CITY OF EAST GRAND RAPIDS

MEMORANDUM

RE: **CC Introduction – Gaslight Investors Planned Unit Development Amendment
2255 Wealthy St. SE and 515 Lakeside Dr. SE (PPNs 41-14-33-276-032 and 41-14-33-276-029) - Concept Plan Review**

CONCEPT SITE PLAN | VEHICULAR CIRCULATION

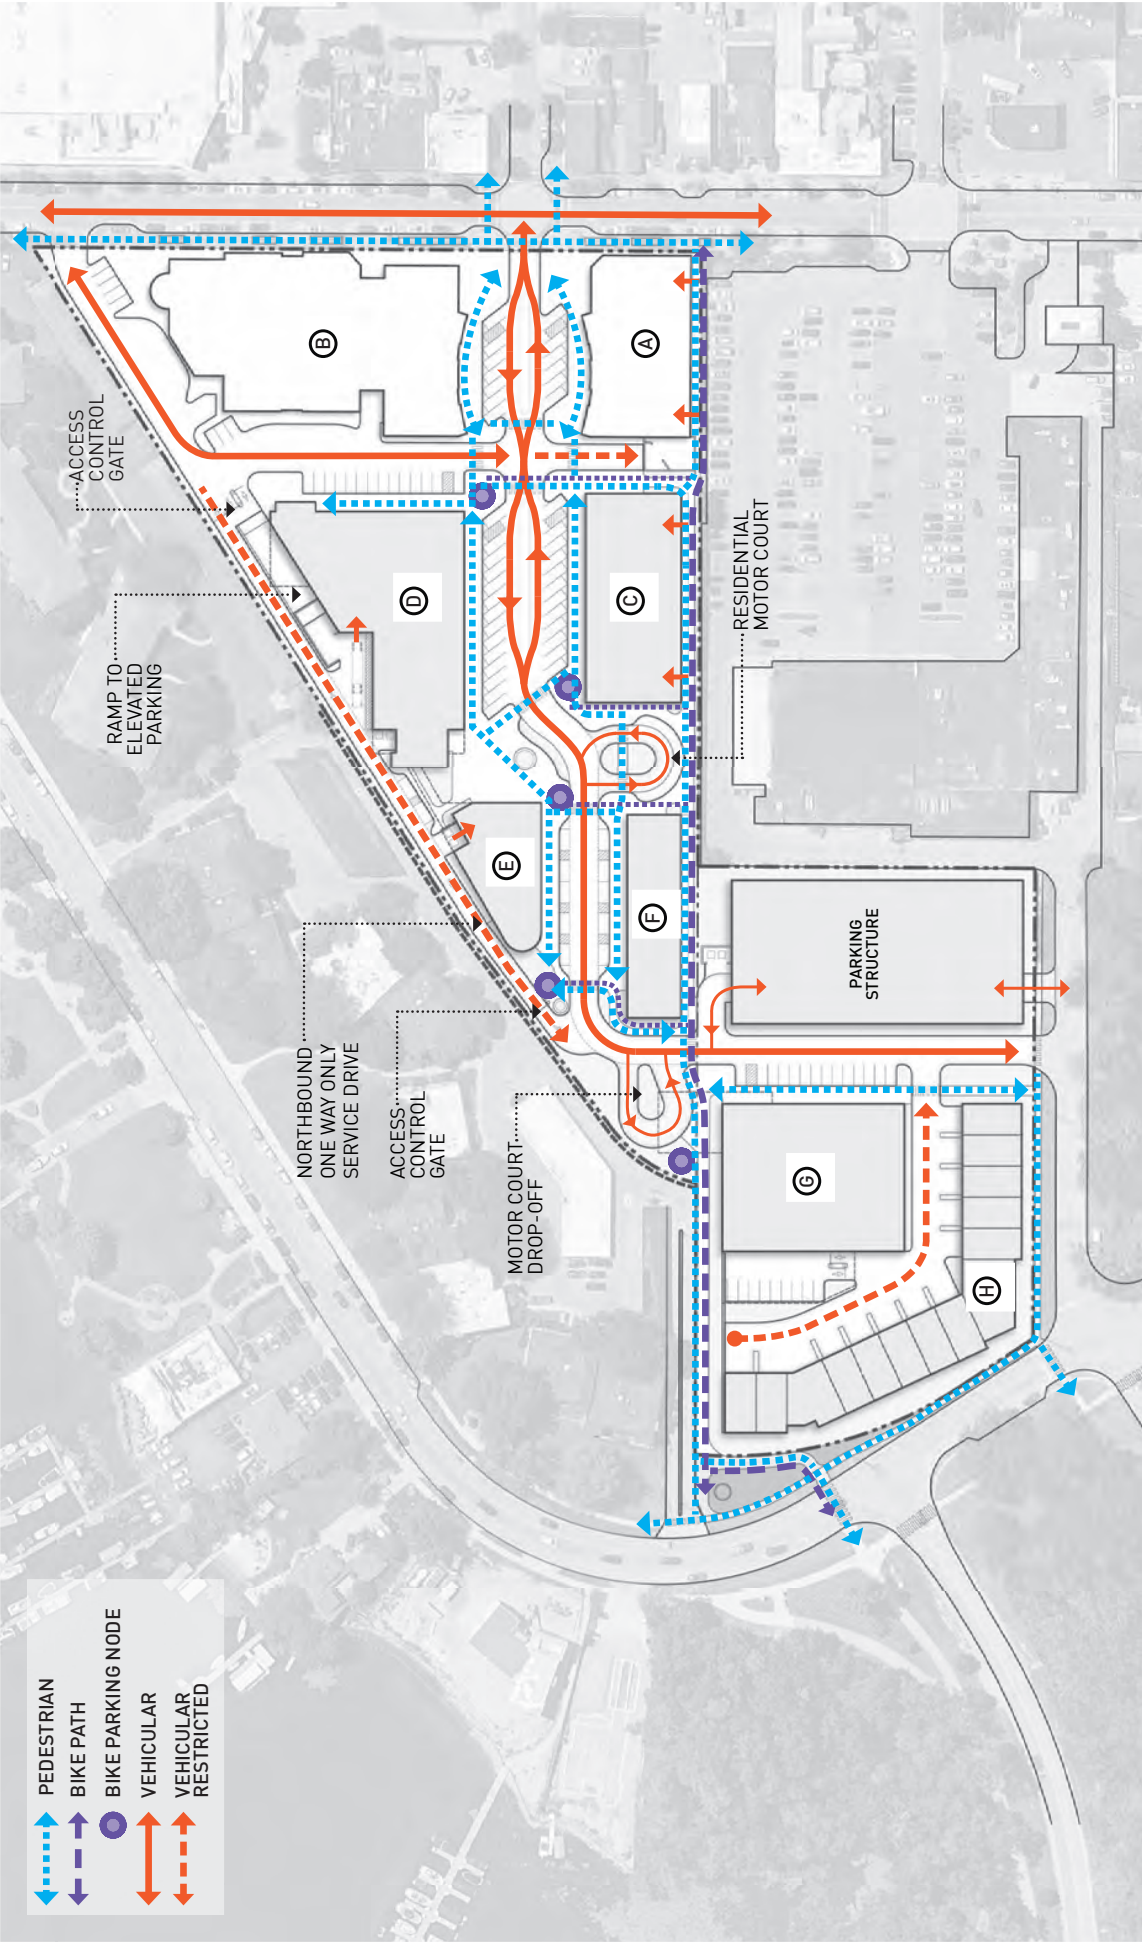
- Truck/service traffic would be directed away from the main interior road into a one-way service road accessed at the SE corner of the property (next to Chase Bank) and travelling northward. While this arrangement would help separate truck traffic from visitor traffic, it does have the potential to increase truck traffic on Lakeside Drive and Wealthy Street. This was not addressed by the preliminary traffic study, though it may not be possible to accurately model these impacts at the concept plan stage.

- More details on pedestrian and bicycle infrastructure should be provided with the final plan. The applicants have provided basic rendering and diagrams showing the general circulation routes for different users. Of note, the proposed bicycle circulation drawing shows a main north-south bike route connecting Lakeside and Wealthy without intermingling with the internal road network. Access points to bike rack stations are noted and would utilize other planned pedestrian infrastructure. Otherwise, these drawings do not provide much detail on what specific types of amenities will be incorporated. While the central island at the Bagley entrance has apparently been removed in this concept, the materials do allude to other pedestrian safety measures that will be incorporated into the final plan. The City has also recommend adopting various recommendations from the National Association of City Transportation Officials (NACTO) and other professional engineering design manuals in other areas such as pedestrian pathways and integrated public amenities.

Figure 3: Potential Mitigation Measures

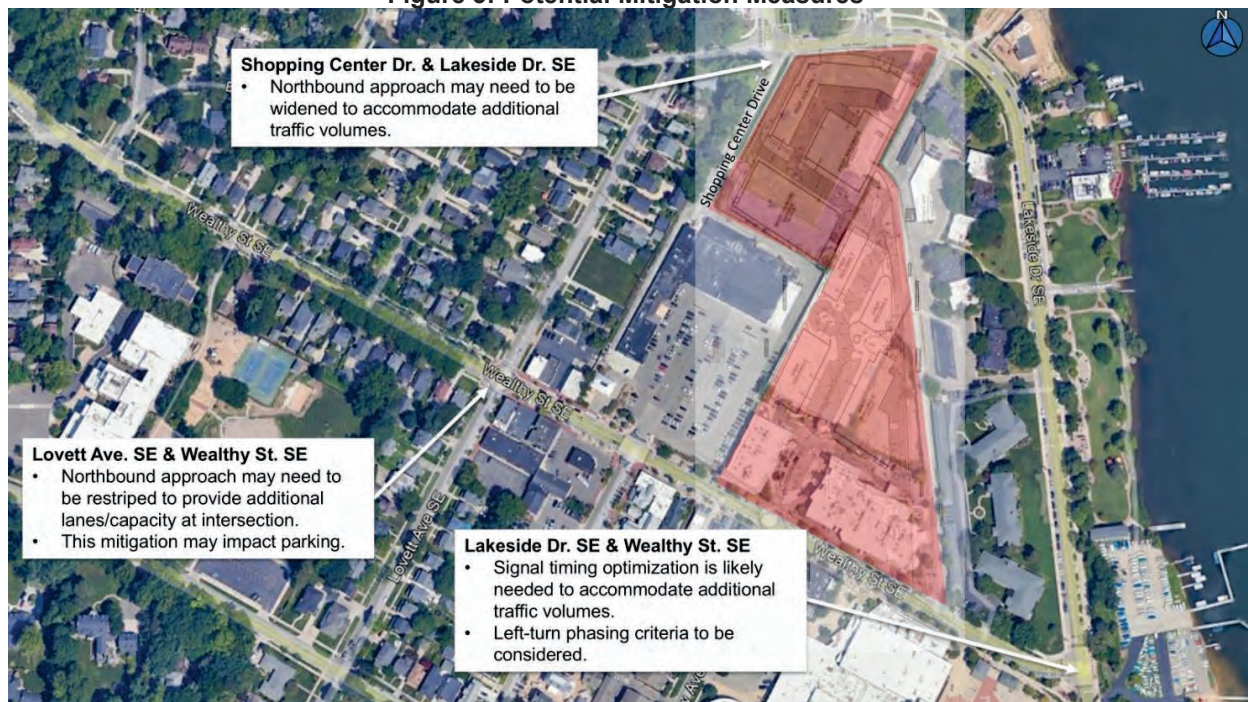
- Some minor modifications to the Lakeside/Shopping Center intersection and the Wealthy/Lovett intersection may be necessary to mitigate traffic from the project. Signal modifications at Wealthy/Lakeside are also recommended to accommodate additional traffic volumes.

- The northbound Lovett Ave. SE approach may need to be restriped to provide additional capacity at this intersection. This may include eliminating some on-street parking to provide a dedicated right-turn lane.

- The existing signal timing will need to be reviewed to determine if optimization is necessary to accommodate the additional traffic volumes. This will need to be evaluated for all study periods.
- A dedicated left-turn phase should be evaluated on the northbound approach.
